Report to Development Permit Panel

File: DP 19-875398

Application by Spires Road Development Holdings Ltd. for a Development

Permit at 8671, 8691, 8711 and 8731 Spires Road

A112 Drawing #:

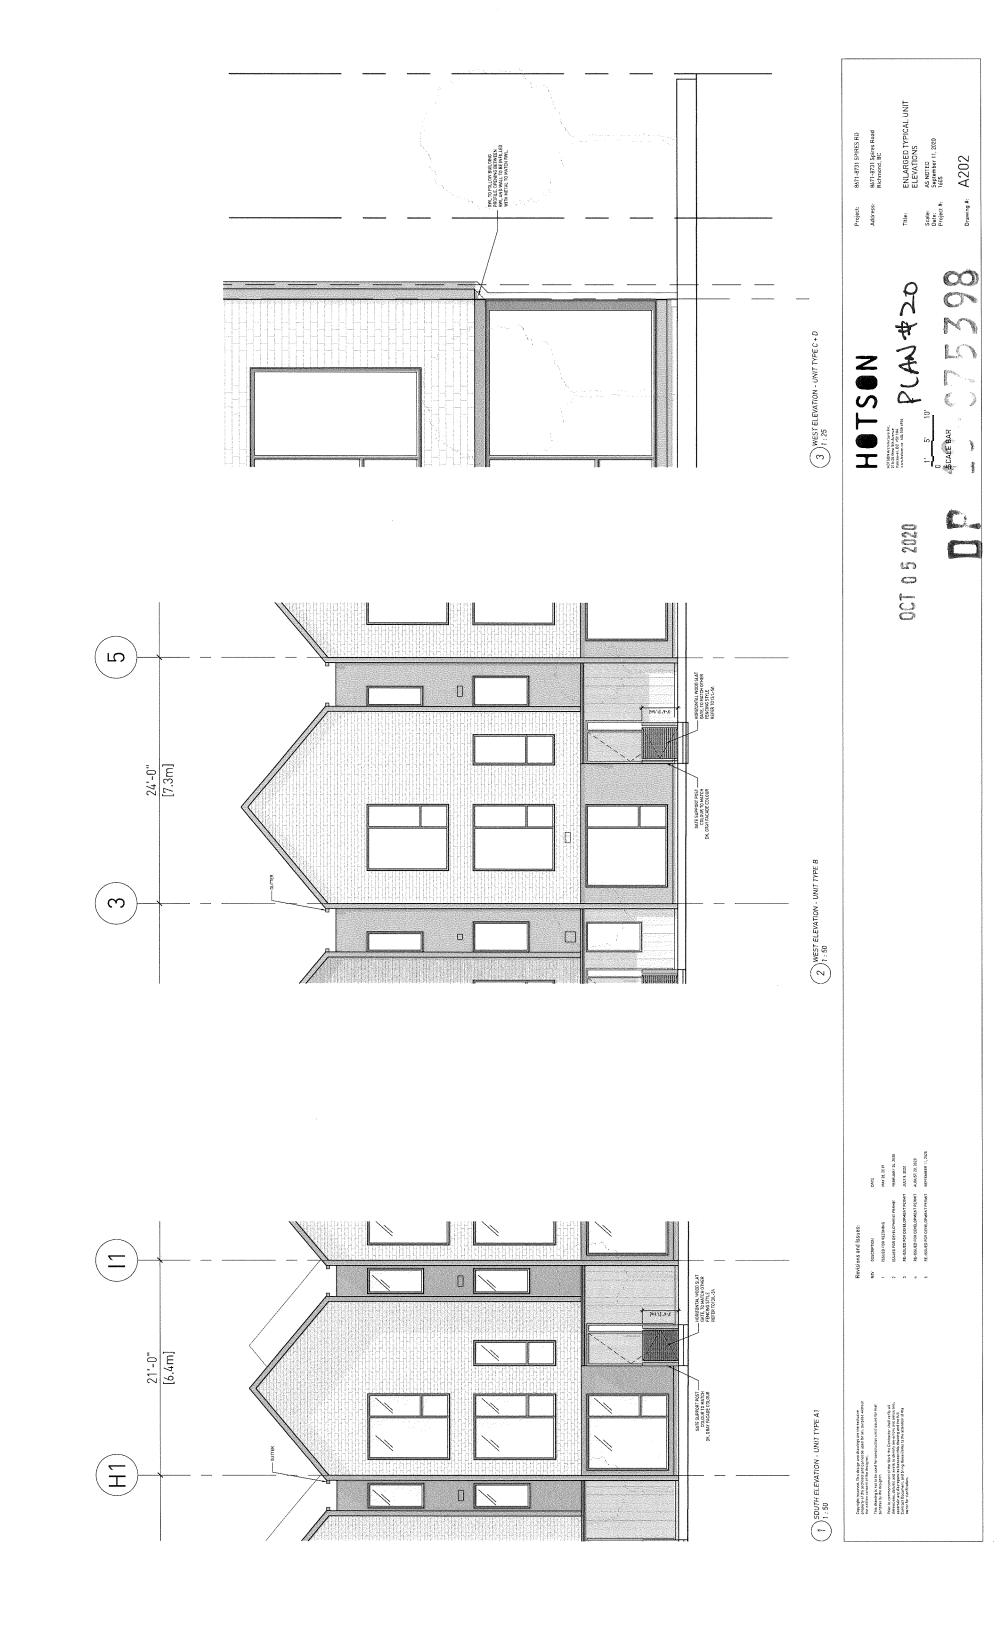
- support the design of the project; like the refreshing look; appreciate the character of the
 podium level courtyard; like the single-family character of the townhouse units fronting the
 street; support the provision of two secondary suites which could be used either for
 affordable rental housing or by a family member;
 Noted.
- appreciate the inclusion of two ground level Basic Universal Housing units in the project; consider installing pocket or sliding doors for the washrooms and closets to create more manoeuvring space and enhance accessibility for residents in a wheelchair;
 Swing doors were selected for the master bedroom and ensuite as it is a requirement from the Richmond Land Use Bylaw Section 4.16.6. Closet doors in master bedroom changed to sliding doors.
- consider assigning the wider accessible parking stall to Unit 1;

The wider accessible stall has been assigned to Unit 1, and the remaining accessible stall will be the visitor stall. Please refer to A111.
- appreciate the contemporary design of the townhouse units; however, caution that additional
 details are needed for the style; it is different from the first development in the Spires Road
 Neighbourhood Area;
 Noted.
